UTILITY BOARD OF THE CITY OF KEY WEST

September 24, 2024

RE: DEVELOPMENT REVIEW COMMITTEE KEYS ENERGY SERVICES COMMENTS FOR MEETING OF SEPTEMBER 26, 2024

Horizontal Clearance Adjacent to Buildings NESC 234C

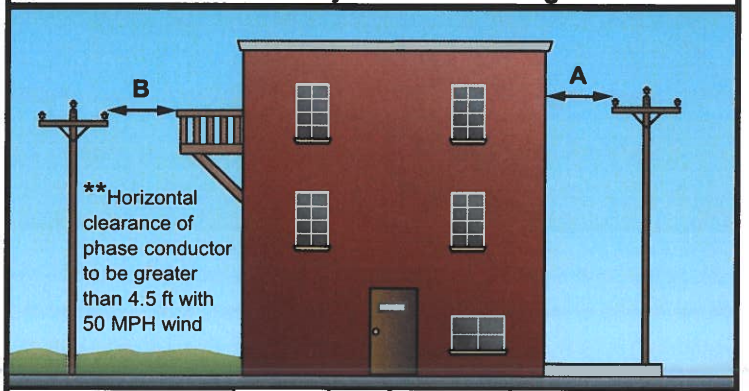
LOCATION: Major Development Plan - 907 Caroline Street
COMMENT: KEYS has no objection to the Major Development Plan request. There needs to be clearances maintained from the building; horizontally to KEYS' neutral 5' feet, and from KEYS' primary 7.5' feet. The vertical clearance for primary 7.5' is horizontally, and 13.5' vertically, per the National Electrical Safety Code rule 232. The OSHA clearance for cranes is 20' feet. Please see the attached language.
